Rezoning Transportation Analysis

Petition Number: 2019-128

Revision Log:

TYPICAL SECTION

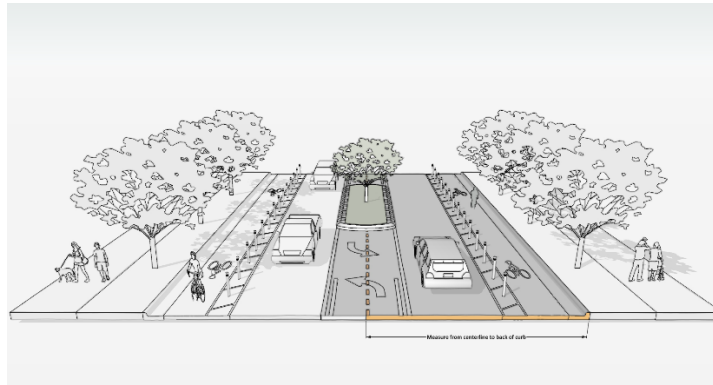
1. **Curbline** The proposed zoning district has a setback measured from back of the existing or proposed future curbline. **Updated Comment: The curb lines should be dimensioned from the centerline. TYP.**
 - a. **Steele Creek Road:** The future location of curb and gutter will be constructed within the Steele Creek Road (NC 160) U-5766 project. The public meeting map and proposed cross section are provided below for reference.

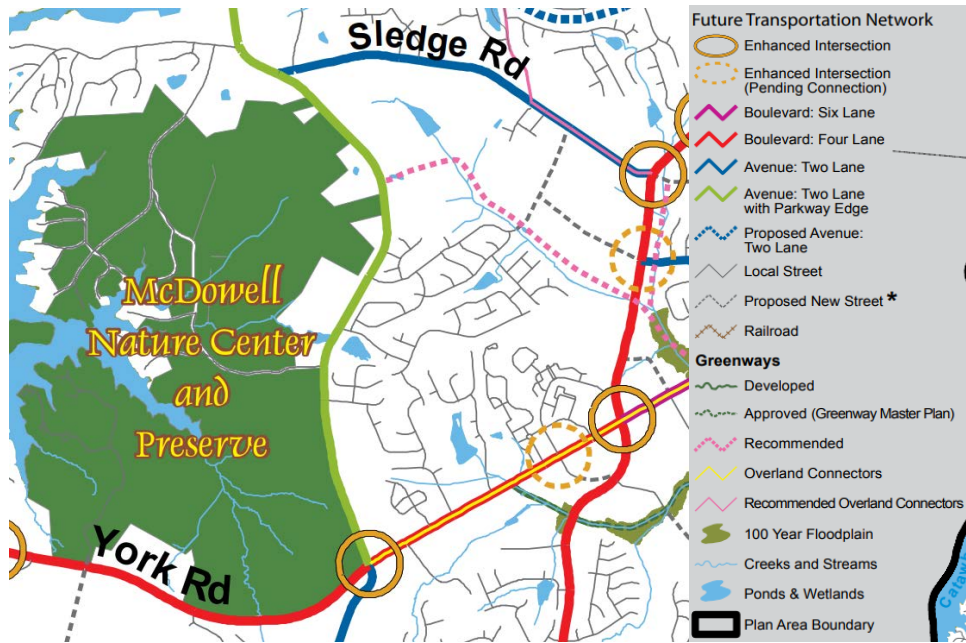
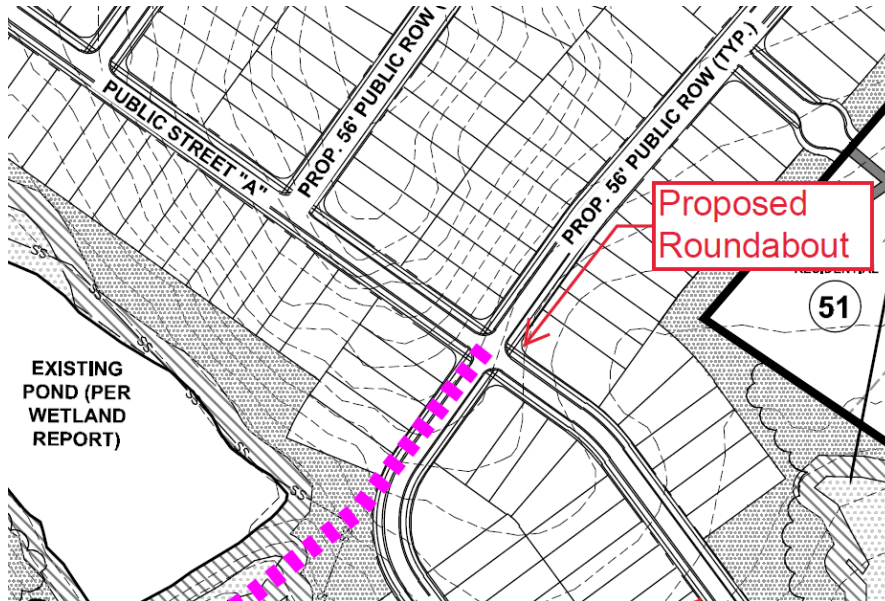
- The petitioner should revise the site plan and conditional note(s) to incorporate a proposed mini-roundabout on proposed Public Street "A."

- The petitioner should revise the site plan and conditional note(s) to revise Public Street "A" to a Local Collector Street Section, per CLDSM U-07, as required by Sec. 20-23(k) of the Subdivision Ordinance and the City-council adopted Collector Street Map. ~~In lieu of the proposed 10-foot multi-use path, a 12-foot multi-use path should be provided along the western streetscape to provide an overland connector to the recommended greenway alignment to the McDowell Nature Center and Preserve.~~

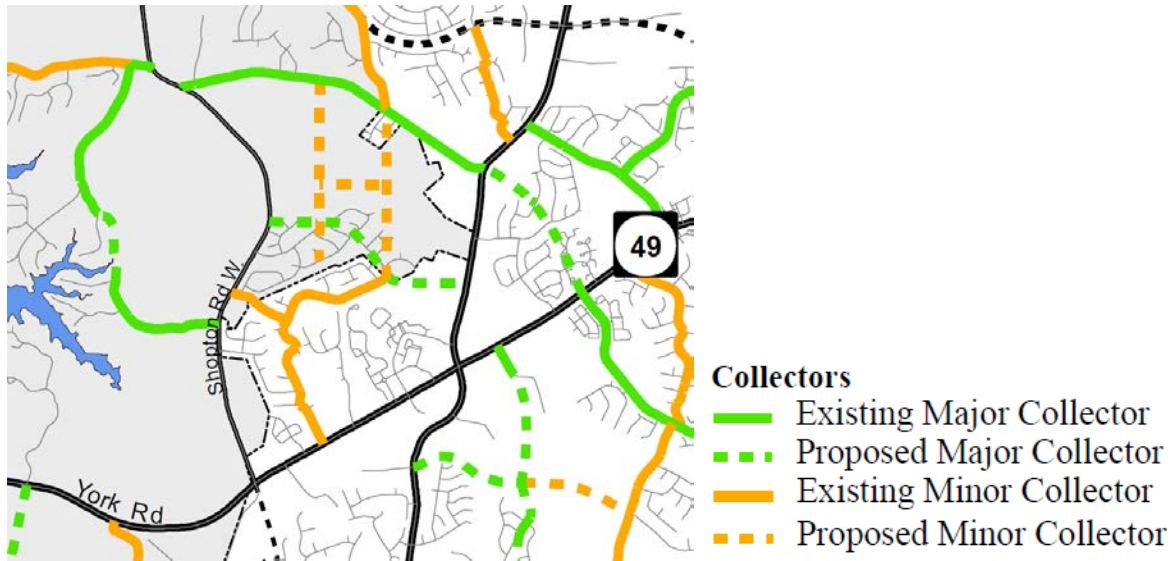
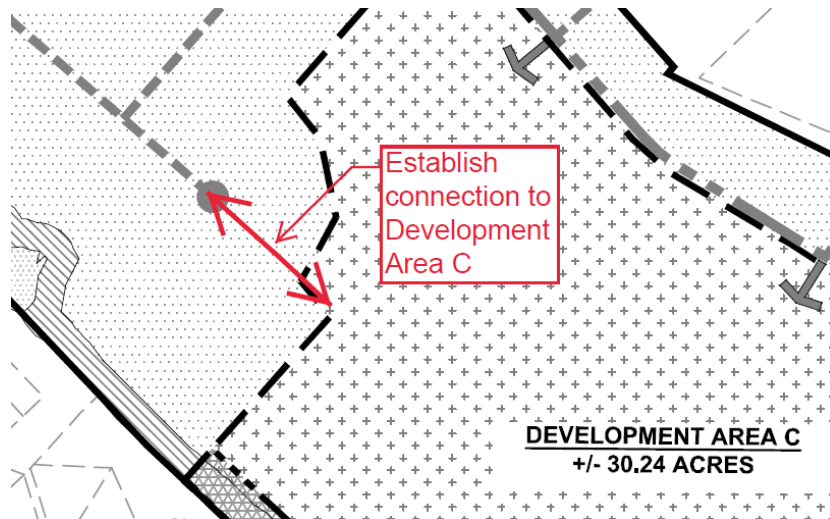
14. The petitioner should revise the site plan and conditional note(s) to establish a street connection to "Development Area C."
